UNITED STATES PATENT AND TRADEMARK OFFICE

Office Action Summary

10/642,413

DETAILED ACTION

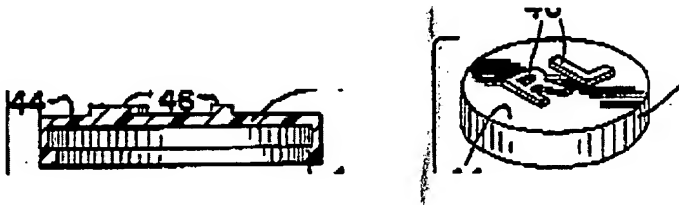
In regard to claim 6, Owens et al. disclose most of the claimed invention except the above- surface design is formed in the background surface of the raised portion of the housing by stamping. Beinhaur et al. teach a well-known method of stamping of the visible indicia (see Col.2, lines 45-46). Therefore, it would have been obvious to one having ordinary skill in the art at the time the invention was made to form a above- surface design in the background surface in structure of Owens et al. by well-known method as stamping, as taught by Beinhaur et al., in order to provide some identification information (indicia).

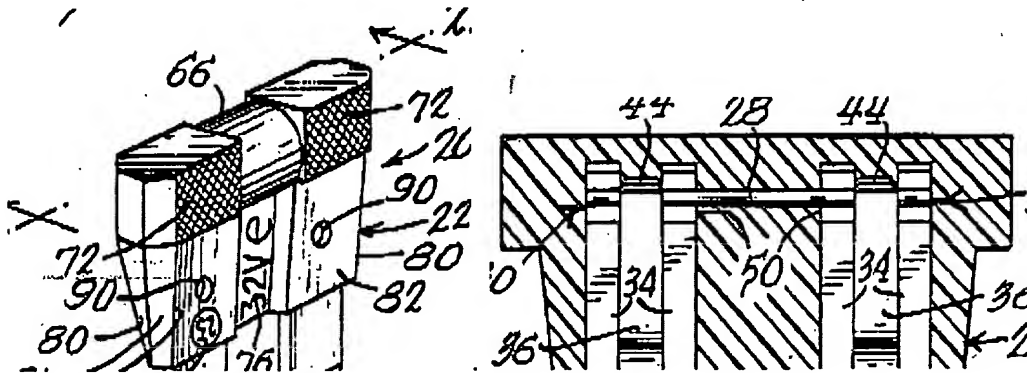
In regard to claims 11 and 16, Owens et al. disclose most of the claimed invention including that the housing 12 has a raised portion 26 and the background surface (top

surface of the raised portion 26) formed of the material along with the housing, except for a design surface formed in the background surface is a gripping surface design formed along with the housing and raised portion of the material, wherein the gripping surface design comprises ridges.

Wiebe teaches a gripping surface 72 formed of the material along with the background surface (and the housing also, see above) and the gripping surface design comprises ridges. The gripping surface 72 permits one to better grip the component 20 and be more comfortable when hold the device.

Therefore, it would have been obvious to one having ordinary skill in the art at the time the invention was made to form a design surface as a gripping surface in Owens et al., as taught by Wiebe, in order to permit one to better hold the connector.
